The City of Spartanburg Design Review Board

AGENDA

PROJECT/ADDRESS/ TAX IDMagnolia Residences/W. Broad Street/7-12-30-4248990;
7-12-30-4153140; 7-12-30-4045895; and 7-11-39-4948449**PROJECT NUMBER**

REVIEW STATUS – continuance - Full and Final**COPIES TO**

PREVIOUS 2/10/25 DRB RENDERING

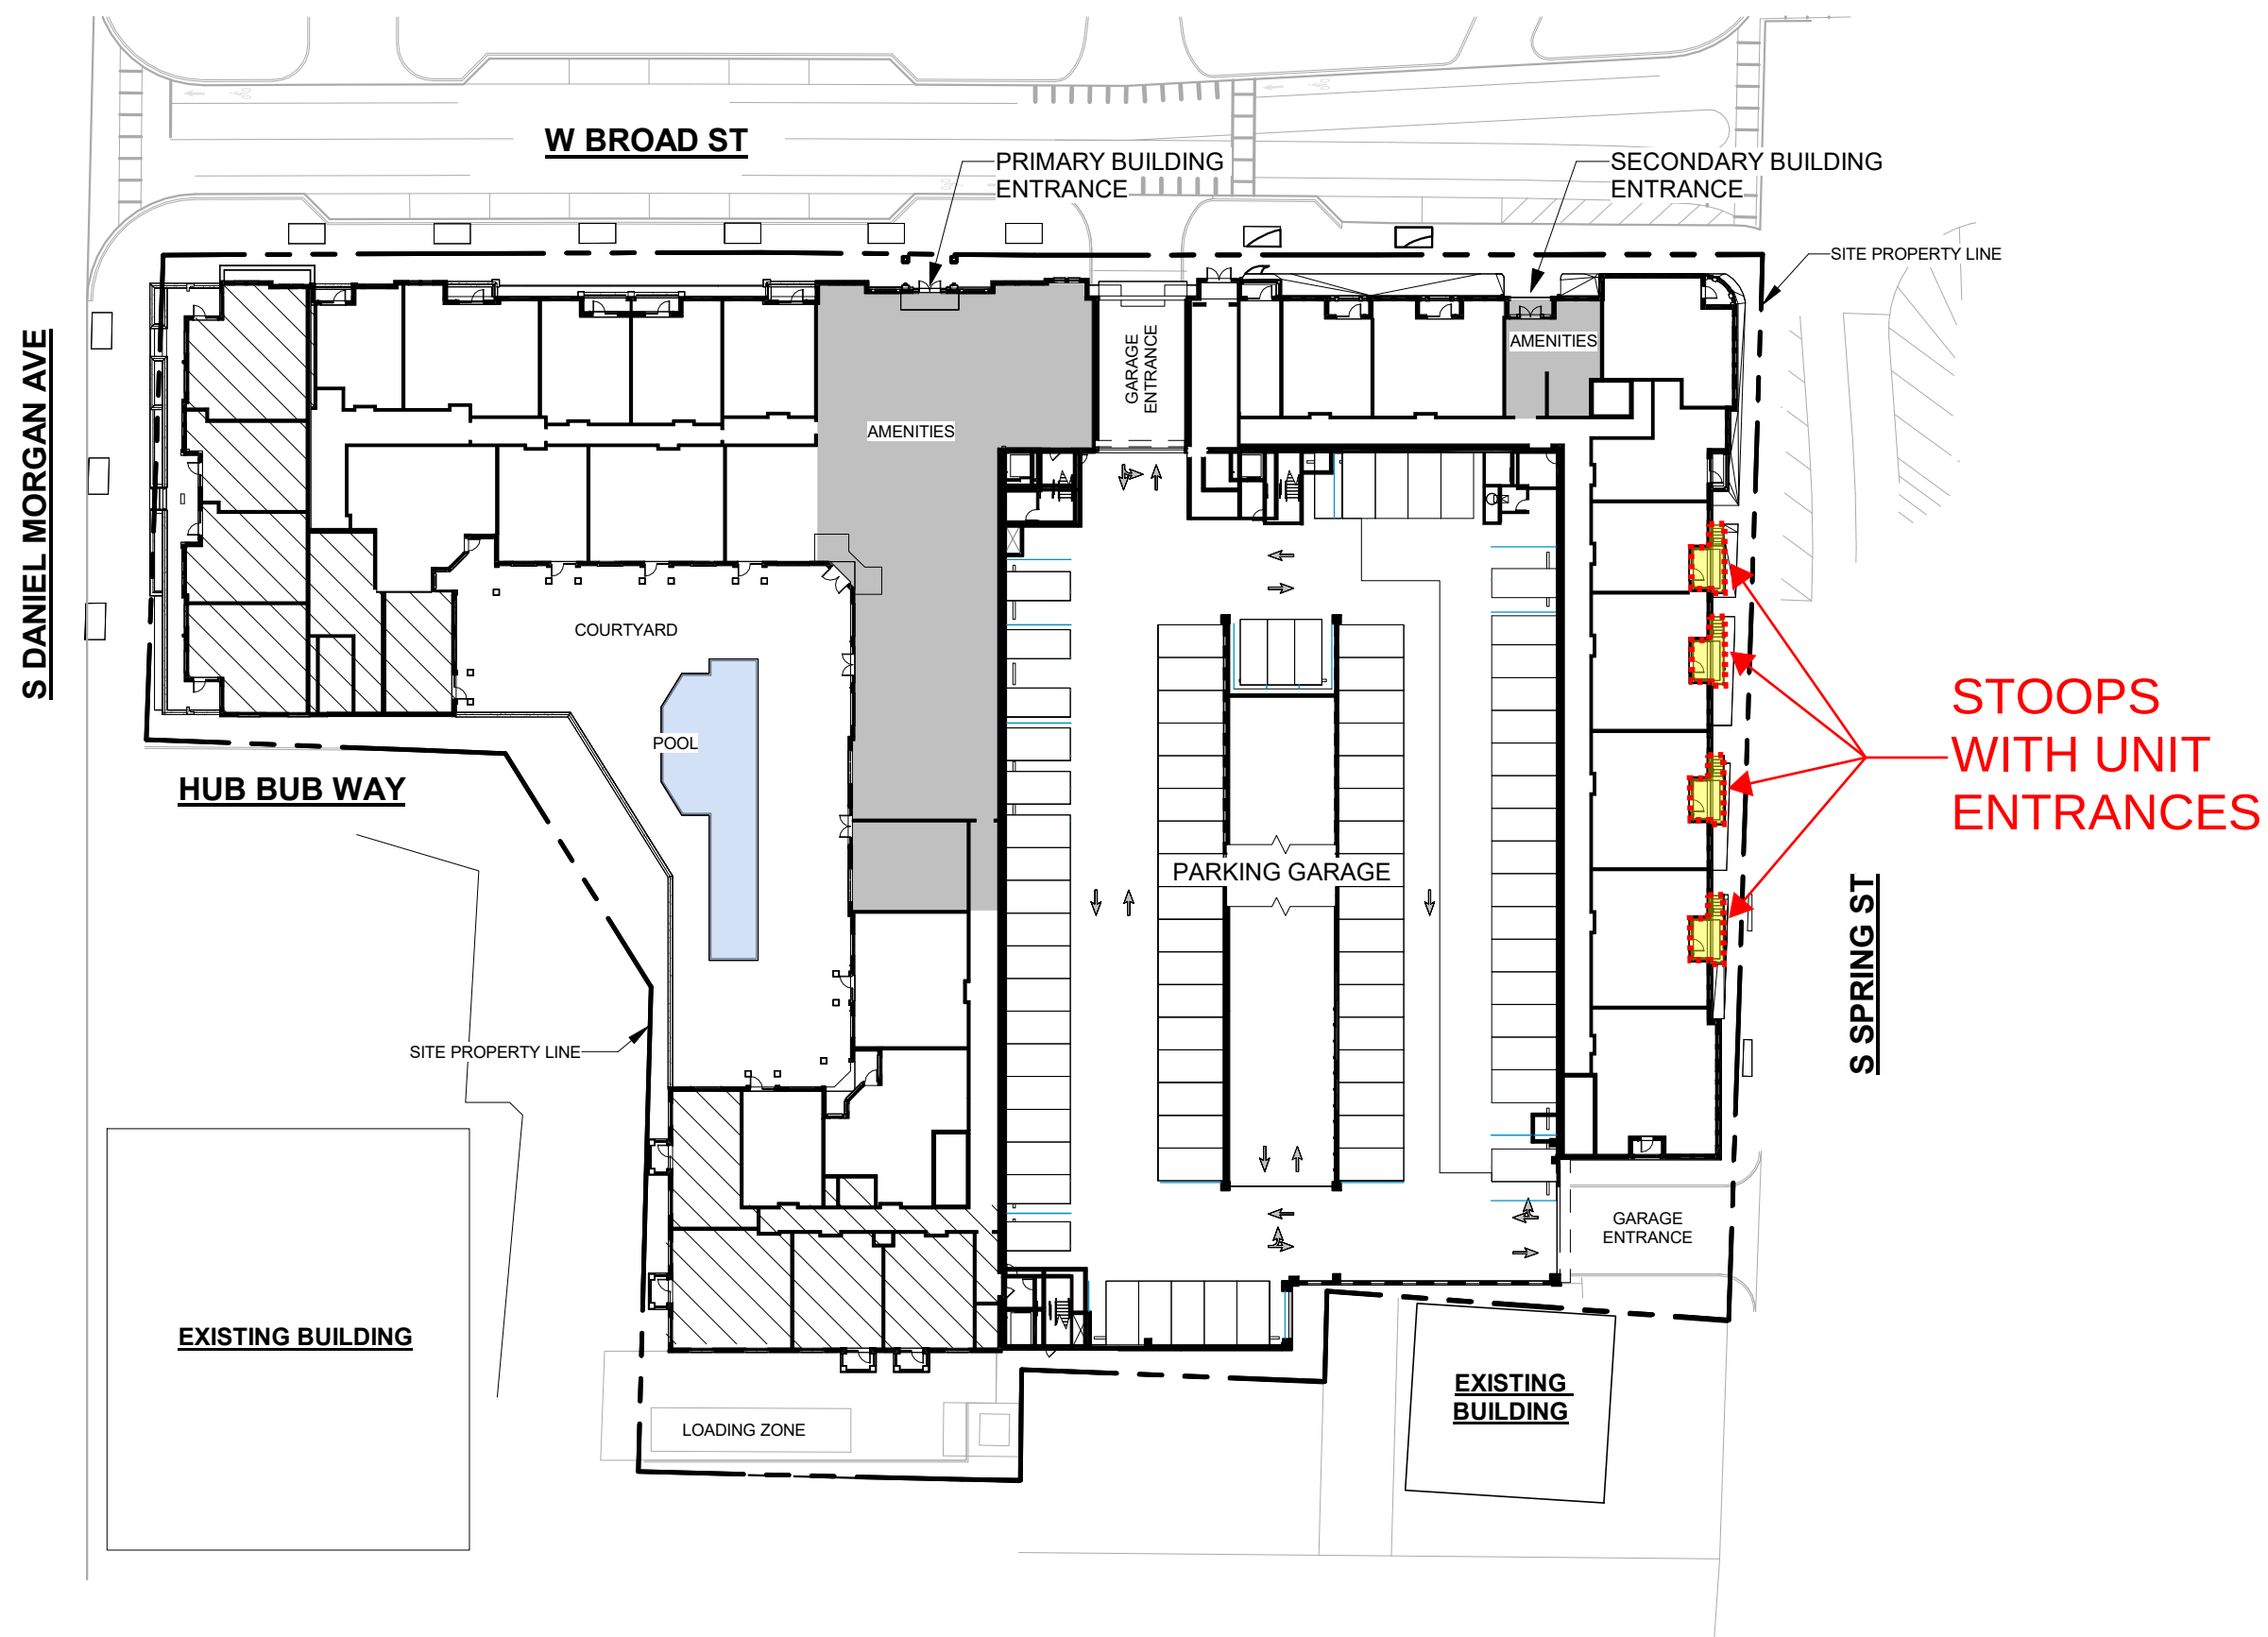
As this area was originally designated as shopfront and the modification to residential conceptually approved; is there a way to open up the corner creating visibility into the common area?

UPDATED 3/19/25 DRB RENDERING

PRIMARY
ENTRANCE
LOBBY (BEYOND)

PREVIOUS 2/10/25 DRB RENDERING

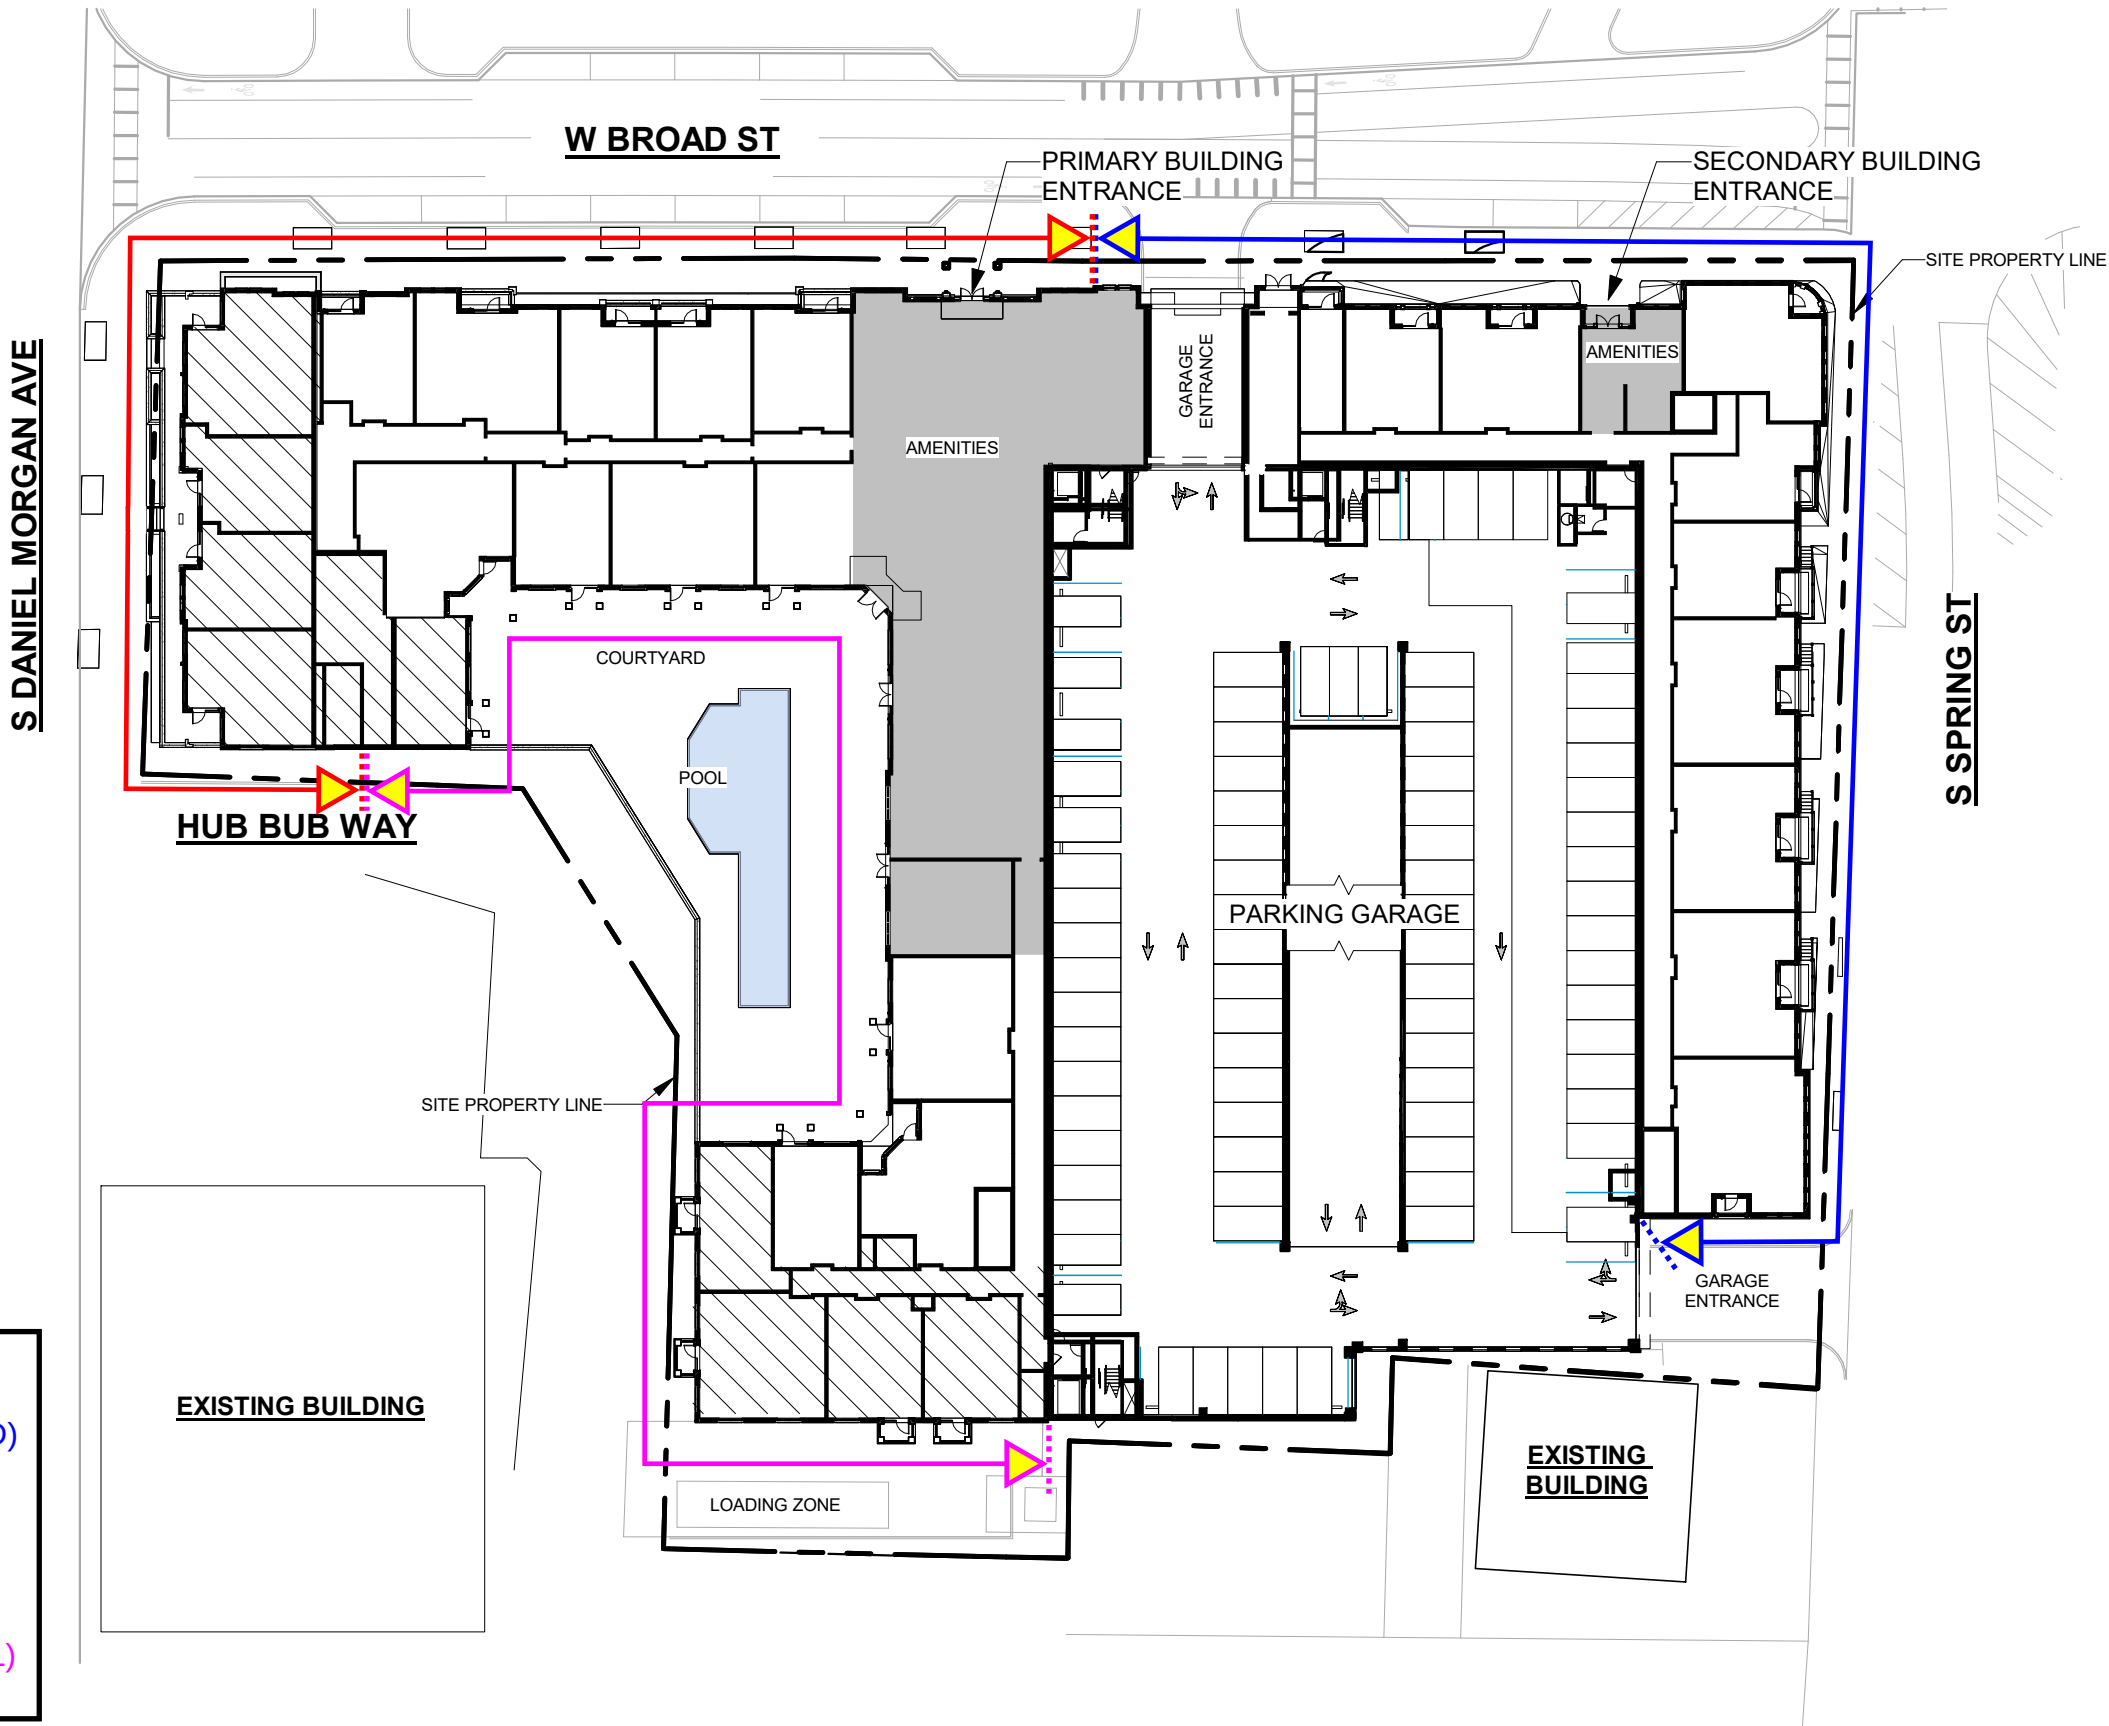
c. Explore a way to use this masonry language for more of the Spring Street section of the building, which would be more internally consistent and more consistent with the character of a city center. Rather than the white (wooden?) spindle railings.

d. Keep the Spring Street side more internally consistent by using the wonderful dark metal railing style, which they are already using for the porches, for the stoop railings too.

RAILING AESTHETIC AT STOOPS
MATCH DESIGN, MATERIAL AND
COLOR OF UPPER BALCONIES.

PREVIOUS 2/10/25 DRB RENDERING

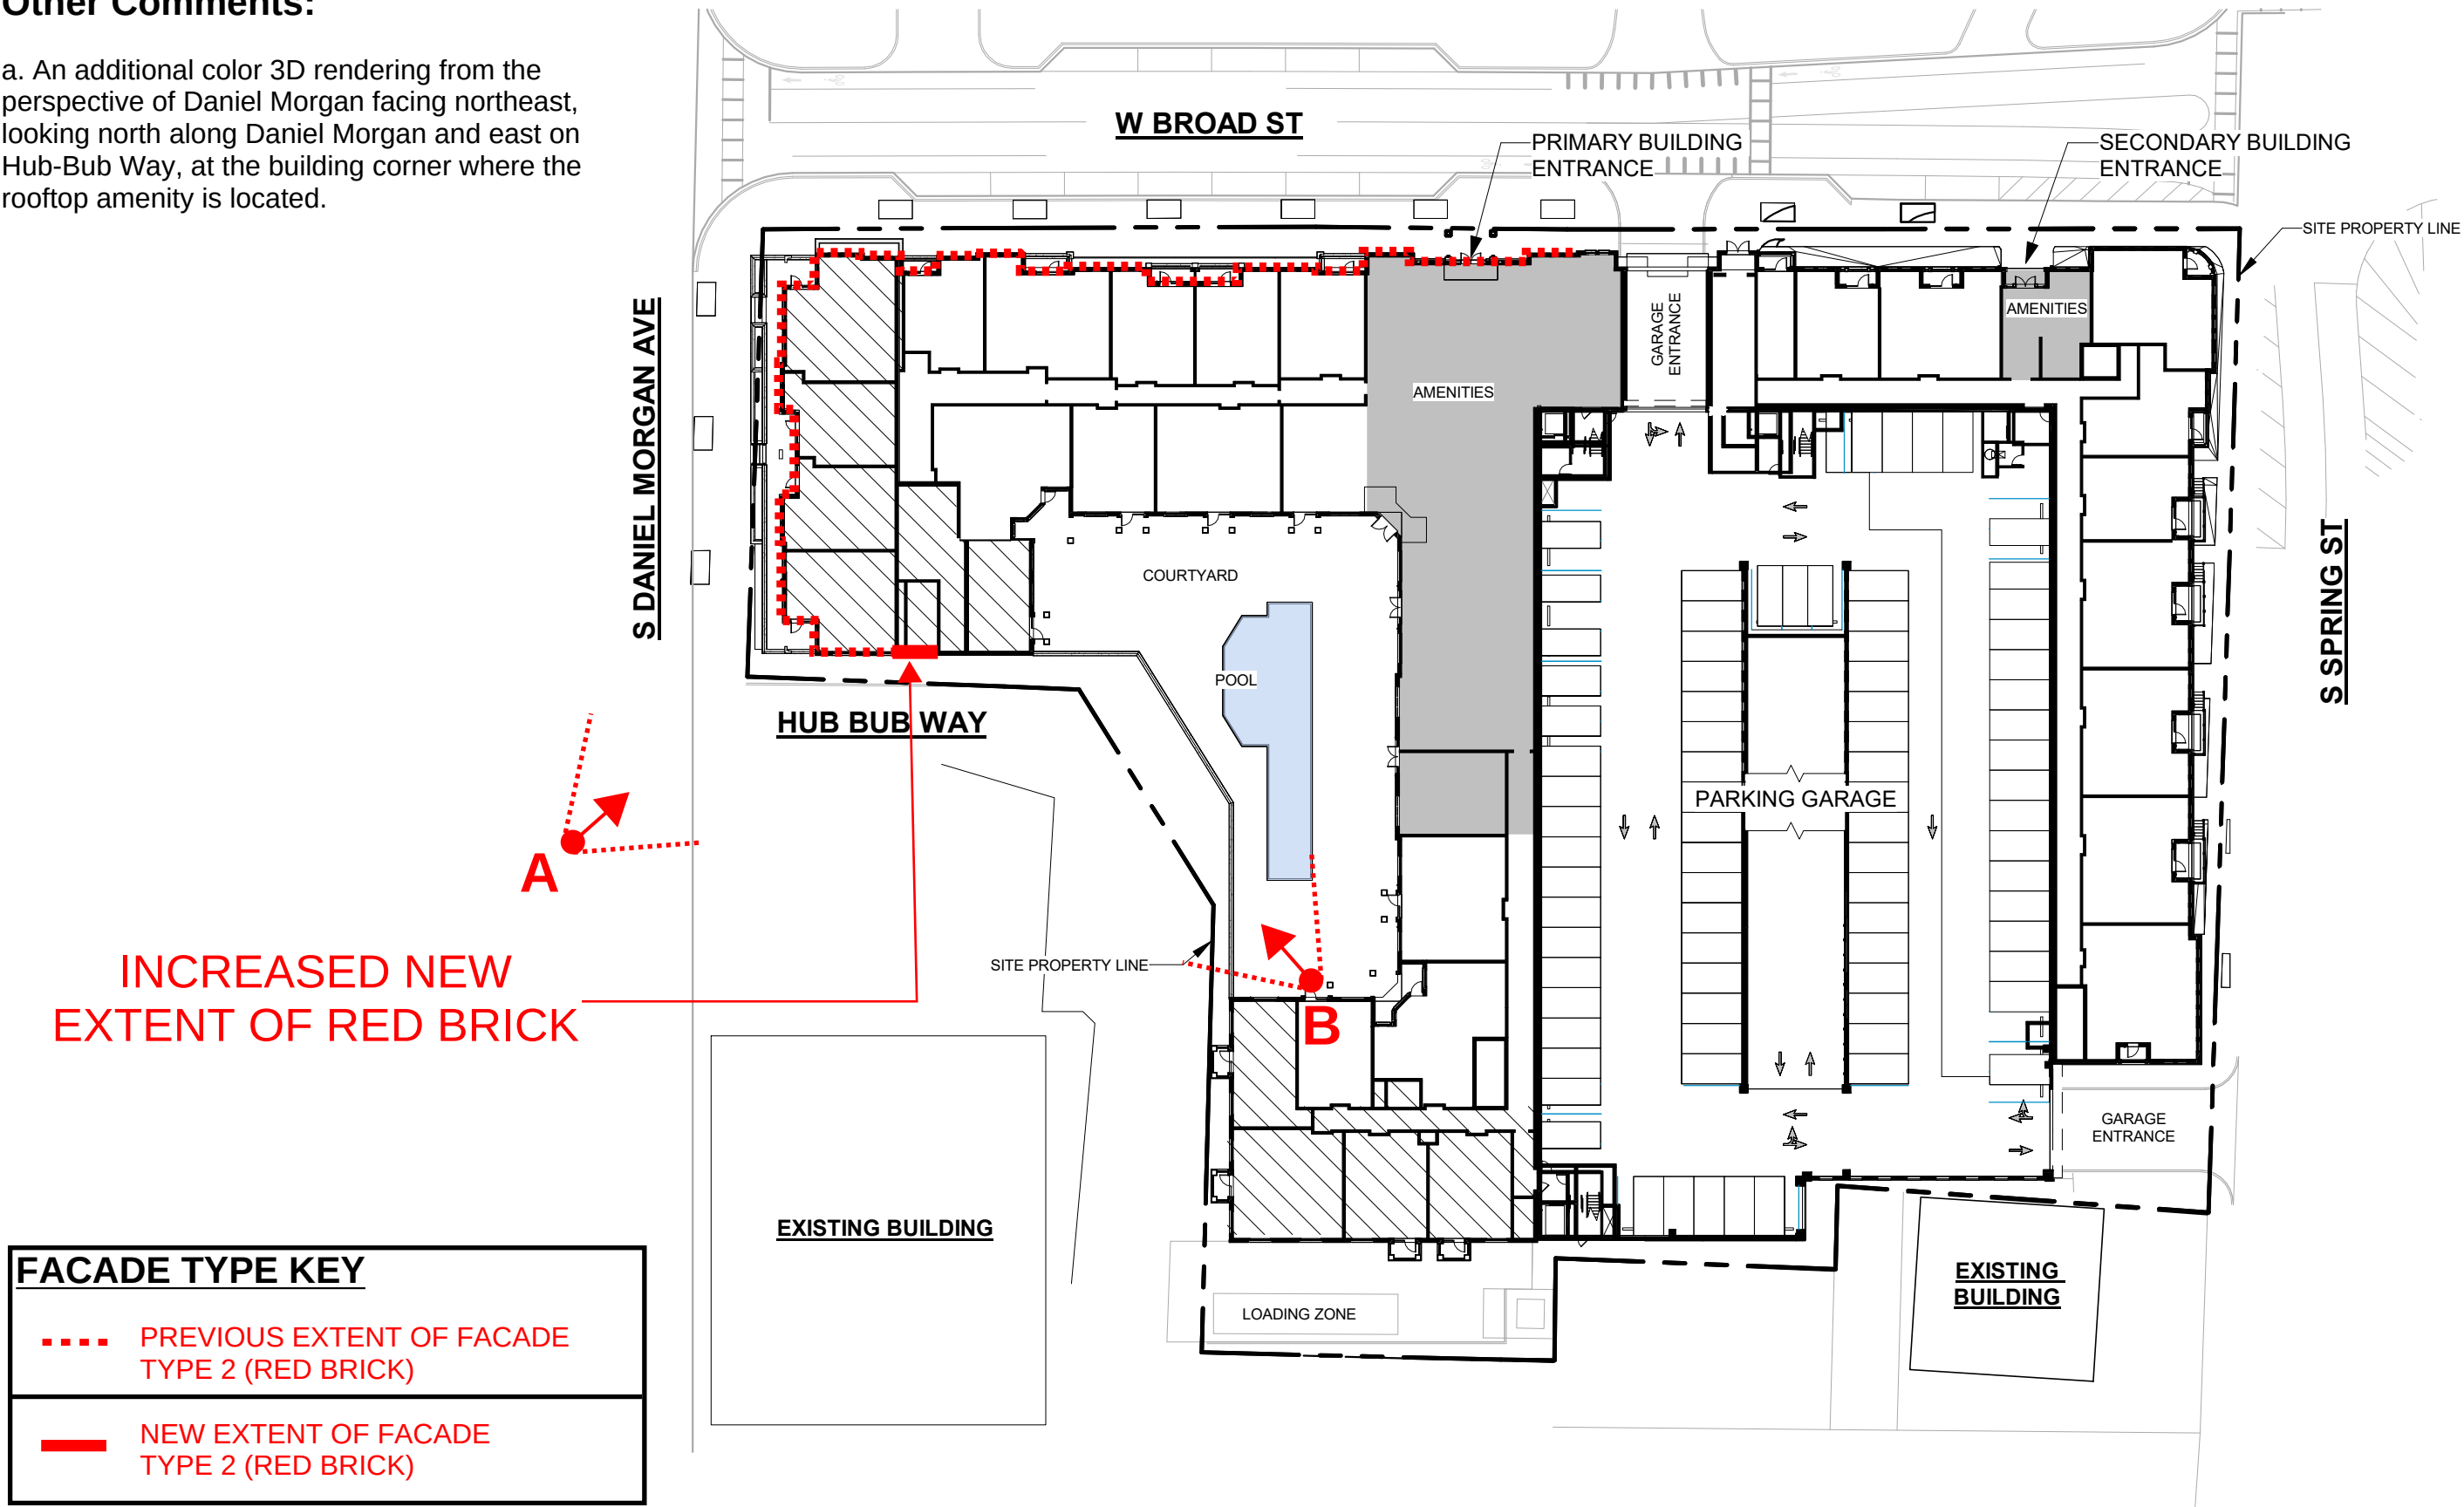
3. Window System Colors

UPDATED 3/19/25 DRB RENDERING
